**THRUSH AIRCRAFT, INC.**

## **SERVICE BULLETIN**

**No. SB-AG-48**

# **FLAP CONTROL TORQUE SHAFT** **REPLACEMENT**

**Figure 48-1: 95661-3 torque shaft crack at linkage arm**

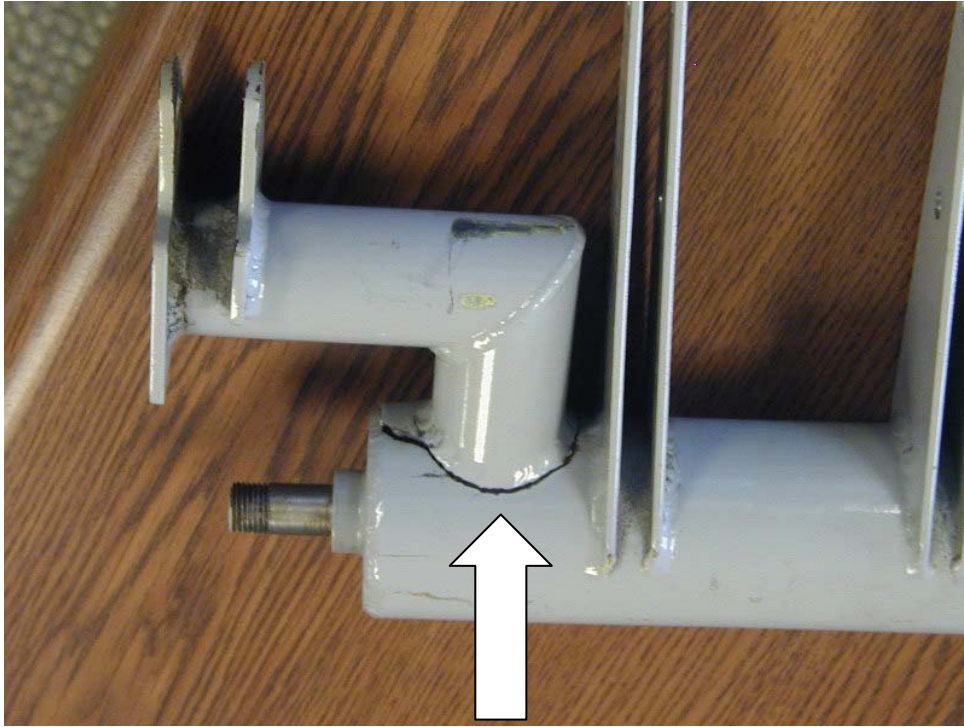
Service Letter SL-AG-108 was issued a year ago because cracks were found on a flap torque shaft assembly P/N 95661-3 where the P/N 95678-1 flap linkage arm welds to the torque shaft. (the problem torque shaft was incorrectly identified as a 95661-1 on SL-AG-108) A similar problem with the same parts was recently reported. Examination of these latest parts makes it evident that the linkage arm joint at the torque tube is not robust enough.

A failure of the linkage arm in flight will cause a sudden roll input, potentially causing an accident. This is especially true when using flaps for a full gross weight take-off. For this reason it is mandatory that the 95661-3 torque shaft assembly be replaced with a strengthened 95661-5 torque shaft assembly.

**INSPECTION:** Ref. Figures 48-1 & 48-2

Inspection requires the removal of wing root fairings and cockpit side skins on both sides of the aircraft, in order to have clear access to the torque shaft assembly. Carefully inspect the weld junction of the flap linkage arm to the torque shaft on both sides of the aircraft.

Cracked, bubbled or discolored paint in the vicinity of the weld must be removed with paint stripper and the weld visually inspected with a minimum 5 power magnifying glass. If a crack is found, the torque shaft must be replaced with the new 95661-5 torque shaft prior to further flight.

Repair of a cracked 95661-3 torque shaft is not permitted.

The 95661-3 torque shaft must be replaced by the 95661-5 torque shaft within 200 flight hours of receipt of this service bulletin.
